APPLICATION NO.	FILING DATE	FIRST NAMED INVENTOR	ATTORNEY DOCKET NO.	CONFIRMATION NO.
10/539,996	06/17/2005	Yuqi Zhang	113124-01US	1200
27189	7590	11/13/2007		
PROCOPIO, CORY, HARGREAVES & SAVITCH LLP			EXAMINER	
530 B STREET			MULLER, BRYAN R	
SUITE 2100				
SAN DIEGO, CA 92101			ART UNIT	PAPER NUMBER
			3723	
			NOTIFICATION DATE	DELIVERY MODE
			11/13/2007	ELECTRONIC

Office Action Summary

DETAILED ACTION

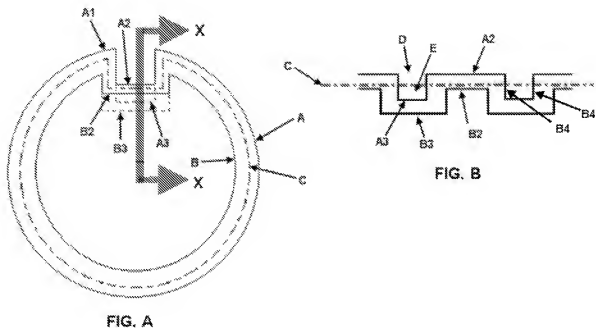
5. In reference to claim 1, Zhang discloses all of the structure disclosed in the claim wherein the inner liner layer is considered to be the inner portion of the inner pipe and the outer portion is considered to be the inner pipe. The applicant does not claim, nor disclose that the inner liner layer is a separate part from the inner pipe. Therefore, the inner pipe is considered to be divided into an inn liner layer and an inner pipe layer. As seen below in figures A and B (Fig. B is a view along line X-X), when the inner pipe is divided along staggered line (C), the inner pipe section is provided with a plurality of detent holes (D) and the inner liner layer, which is fixed to the inner wall of the inner pipe section will clearly isolate the vacuum of the inner pipe from the detent holes.

6. In reference to claims 2 and 3, Zhang further discloses the locking device having all of the structure claimed in claims 2 and 3.
7. In reference to claims 4 and 5, Zhang further discloses that the second guiding member is a guiding slot (12) axially disposed at the outside wall of the inner pipe, and said first guiding member is a guiding rib (11) axially disposed at the inside wall of said guiding bush and slidably moved within said guiding recess, wherein the detent holes (9 or D above) are disposed at said guiding slot.

8. In reference to claim 6, Zhang further discloses that said inner liner layer is an inner liner tube (as shown in Fig. A above) which is provided at its outer wall with a groove (B3 above) extending axially along said inner liner tube and facing said detent holes.

9. In reference to claim 7, Zhang further discloses that a clearance (E above) is provided between the outer surface of the inner liner tube and the inner surface of the

inner pipe, and when the locking device is in the locking state, the detent pin will penetrate through one of the detent holes (D above) into the clearance.

10. In reference to claim 8, Zhang further discloses that said inner liner tube is provided with end sealing members (B4 above) at two ends of said groove to block the clearance between the outer wall of said inner liner tube and the inner wall of said inner pipe.
